Butler Trail Code Amendment

Leslie Lilly
Environmental Conservation Program Manager

Proposed Amendment

Proposed Amendment (1/3)

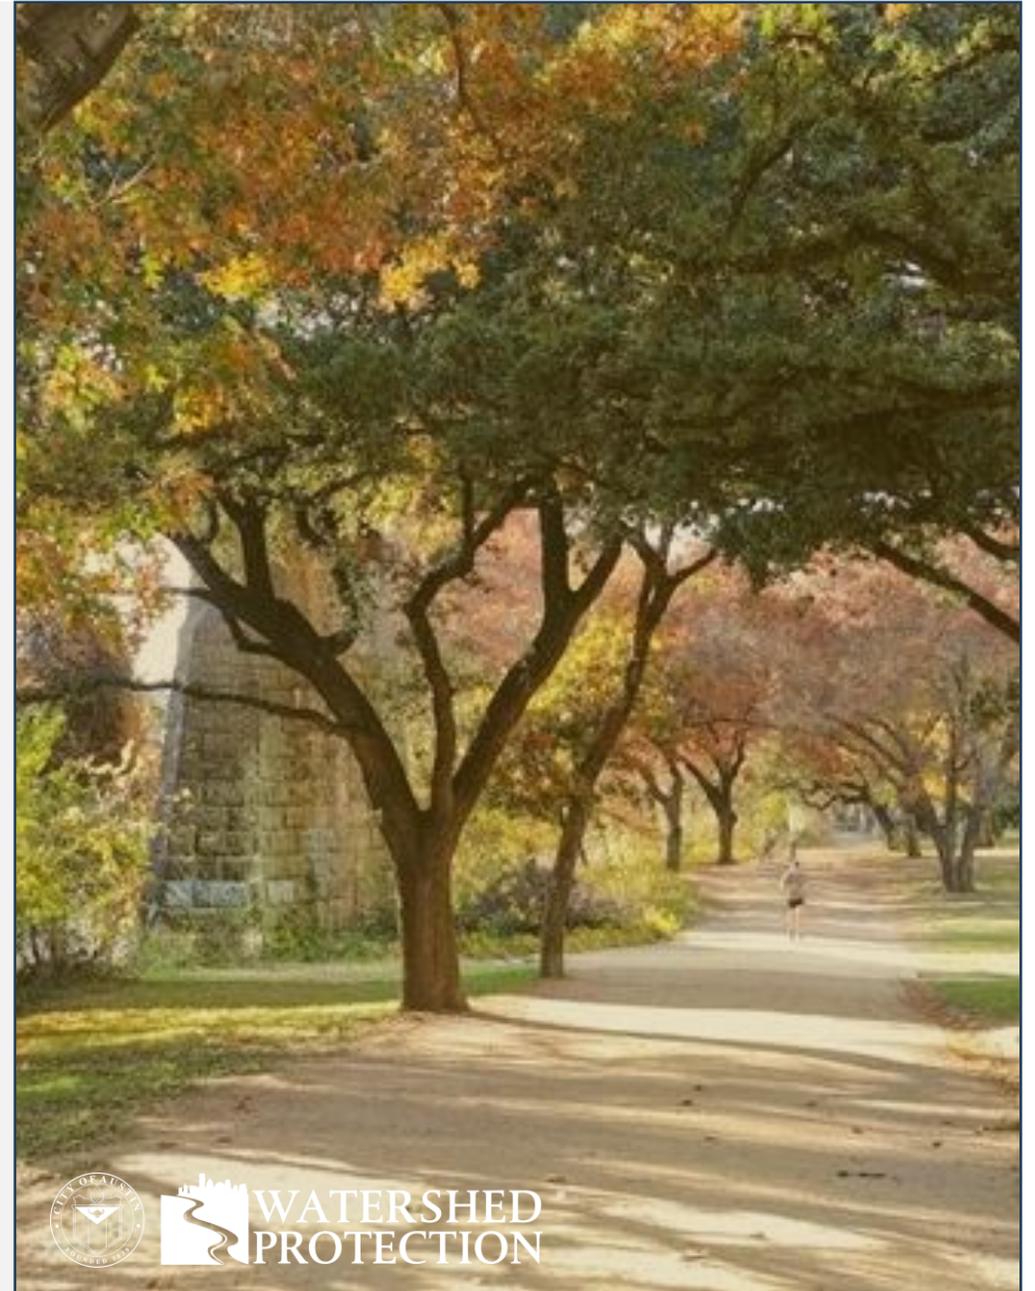
(c) limited to 12 feet in width plus one-foot compacted sub-grade shoulders, unless a wider trail is designated in a Council-adopted plan **or the trail is a part of the Ann and Roy Butler Hike and Bike Trail system;**

Proposed Amendment (1/3)

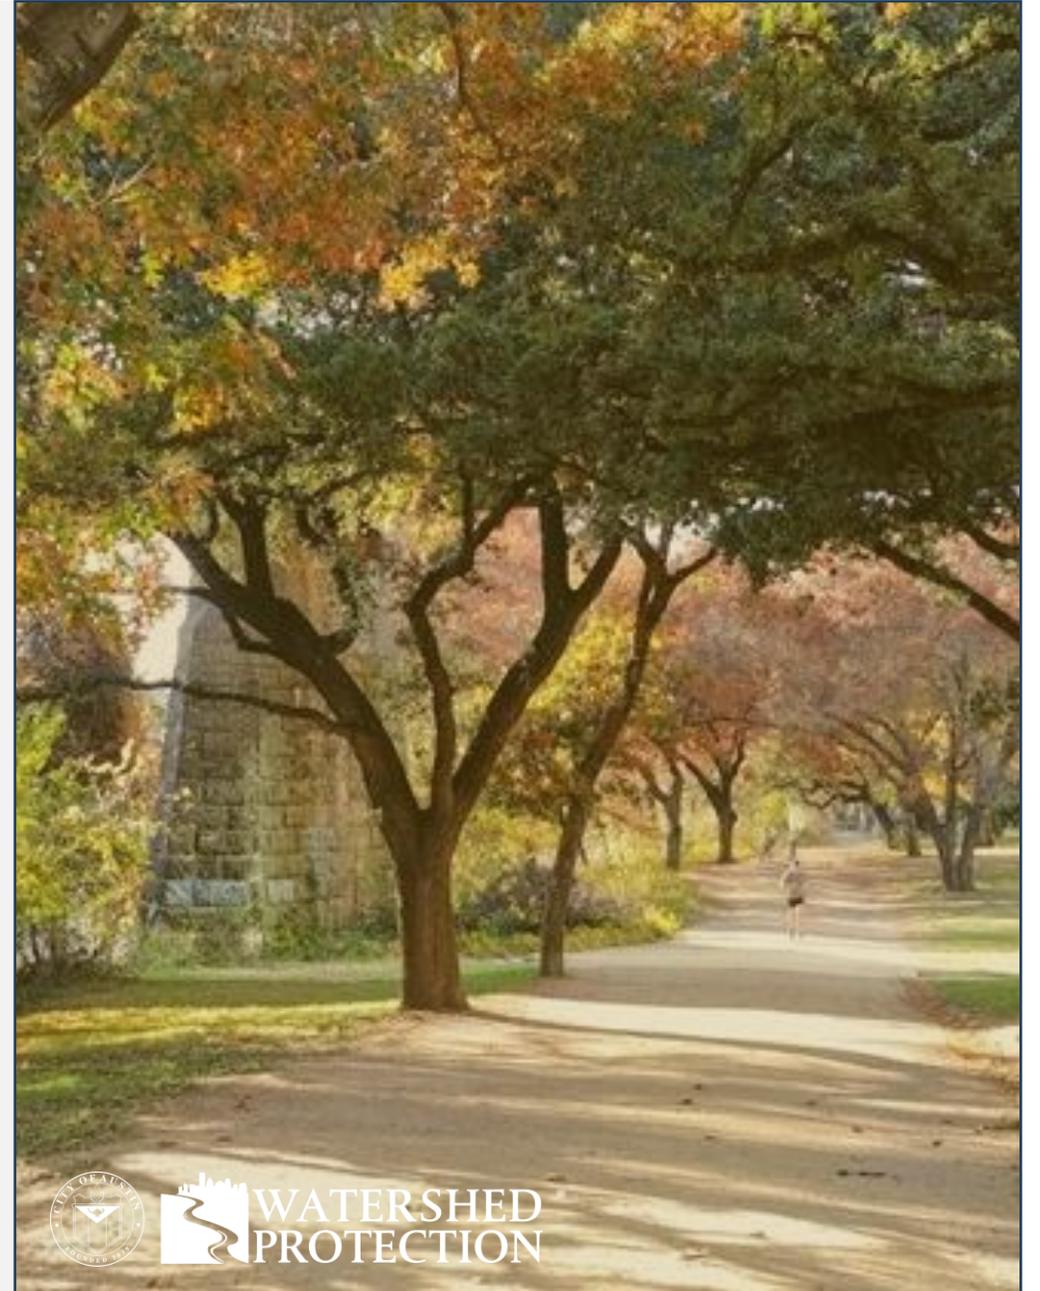
- (f) located not less than 50 feet from the shoreline of Lake Travis, Lake Austin, Lady Bird Lake unless necessary for the construction of the Ann and Roy Butler Hike and Bike Trail system as allowed in (g) below, and Lake Walter E. Long, as defined in Section 25-8-92; and
- (g) located not less than 50 feet from the shoreline of Lady Bird Lake as defined in Section 25-8-92, unless restoration is provided at a minimum ratio of 1:1 with the option that the applicant and the Director collaborate to reach up to 2:1, as determined by a functional assessment of floodplain health; or alternative compliance as approved by the Director is provided.
- (g) (h) located not less than 100 feet from the ordinary high water mark of the Colorado River downstream from Longhorn Dam.

Proposed Amendment

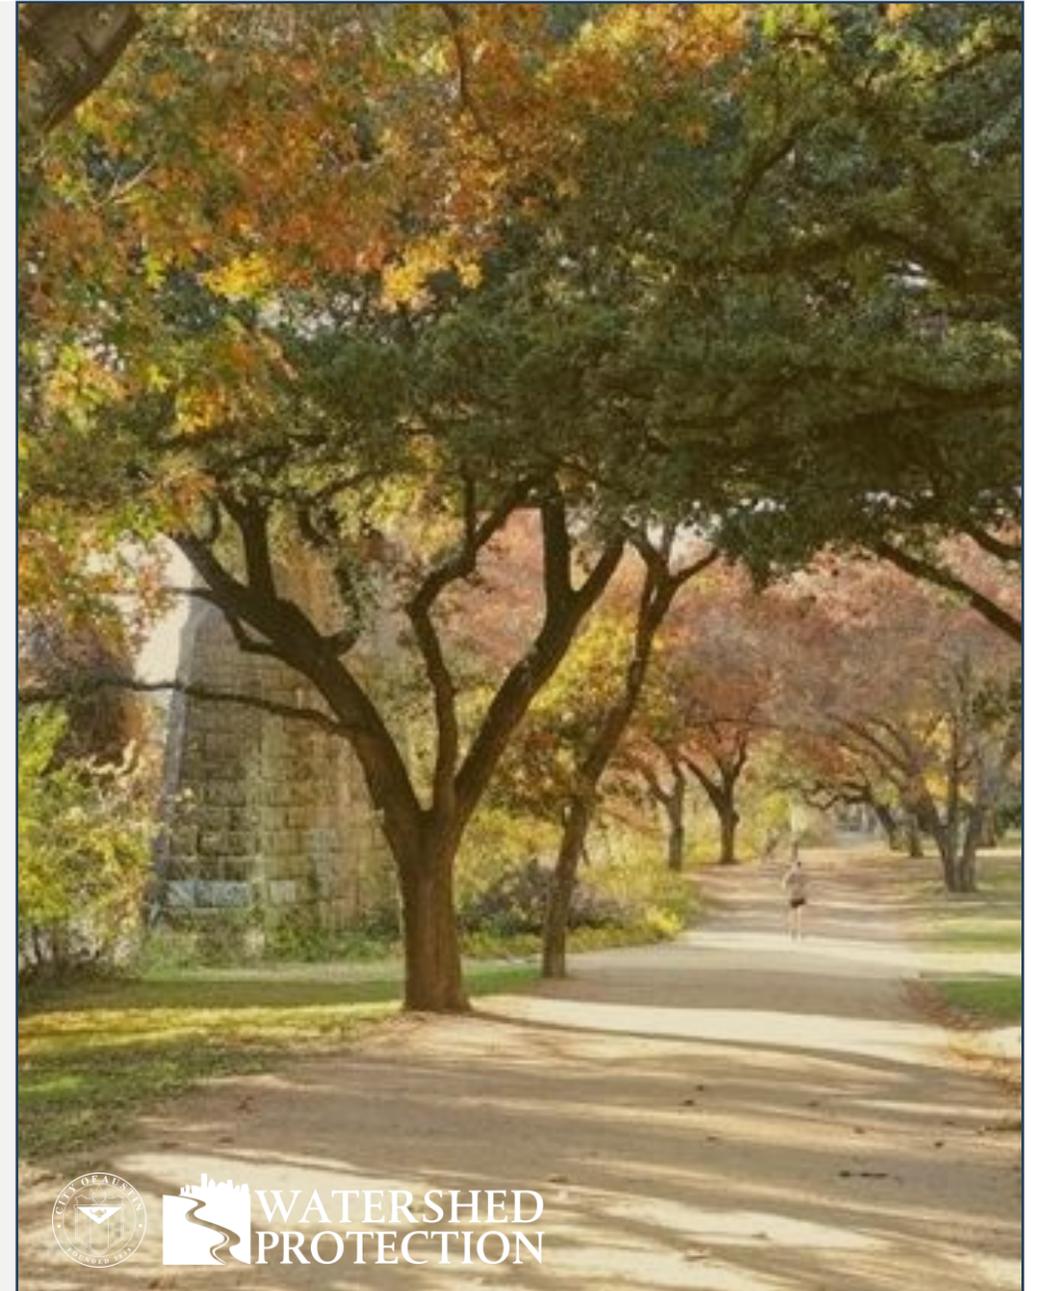
- (2) Disturbed areas **not associated with the Ann and Roy Butler Hike and Bike Trail System** must be restored in accordance with the Environmental Criteria Manual and the following requirements:
